OCTOBER 17, 2017 ZONING HEARING "OTHER BUSINESS" COMMISSION DISTRICT 3

ITEM 049

To consider granting a Special Exception for a reduction of public road frontage as recommended by the Board of Zoning Appeals from their September 13, 2017 Variance Hearing regarding Variance Application V-96 Michael A. Matthews.

APPLICANT: Michael A. Matthews **PETITION No.:** V-96

APPLICANT: Michael A. Matthews	PETITION No.:	V-96
---------------------------------------	---------------	------

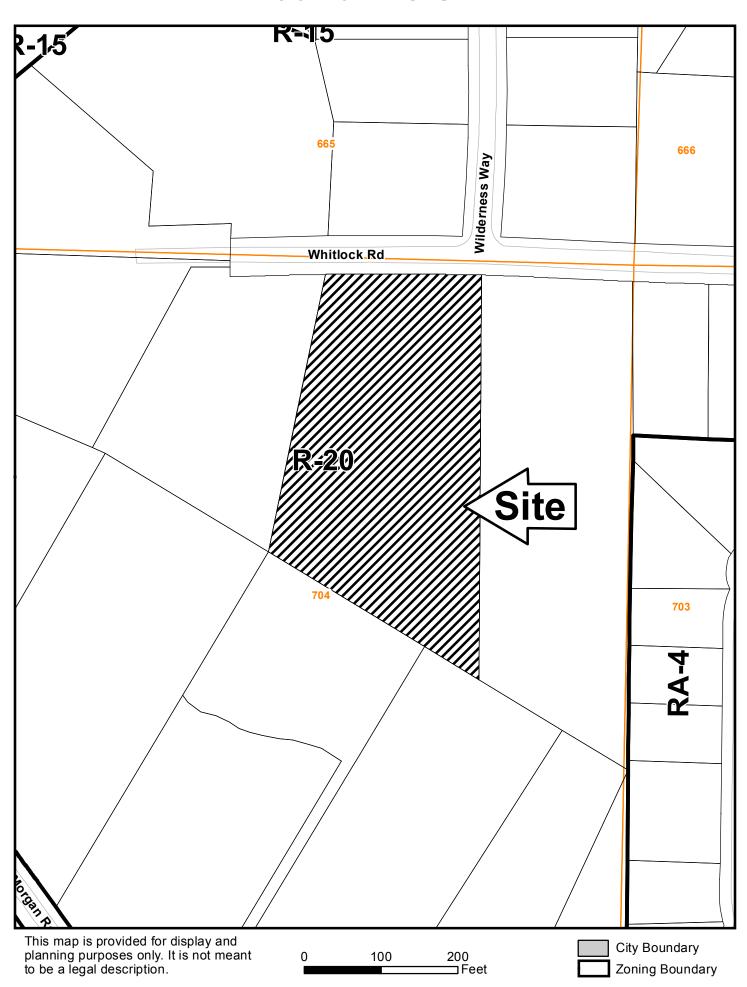
FIRE DEPARTMENT: - Driveway must have a minimum 12'driving surface width with minimum 25' inside turning radius.

- Fully developed landscaping shall be at least 7'0" from center of drive (14'clear width) and 13'6" vertical clearance. (Indicate on plan minimum setbacks).

- Maximum grade shall not exceed 18%.
- Driveway must extend within 150' of the most remote portion of the structure.
- Driveway is limited to 1000' maximum from roadway unless an approved turn-around is provided. (See note below.)

- Driveway must support 25 Tons (50,000 lbs.)
- Provide emergency access to all gates securing Fire Dept. access with a minimum 12'-0" clear width
- Hydrant within 500' of remote structure, minimum 6" main*

- (Required Flow: 1000 gpm @ 20 psi)
- Fire Flow Test from closest existing hydrant*
- (Required Flow: 1000 gpm @ 20 psi)
- * An alternate equivalency for the above hydrant/flow test requirements, subject to approval by the Cobb County Fire Marshal's Office is one of the following:

- 1.) Complete structure treated with a Class-A Fire Retardant spray meeting a flame spread of 25 or less and smoke development of 450 or less.

-Dead-end access roads in excess of 1000 feet shall be provided with a turn-around. Residential cul-desac without island: 38-foot outside radius. Hammerhead turn-around: total of 120 feet needed (60 feet from center of drive).
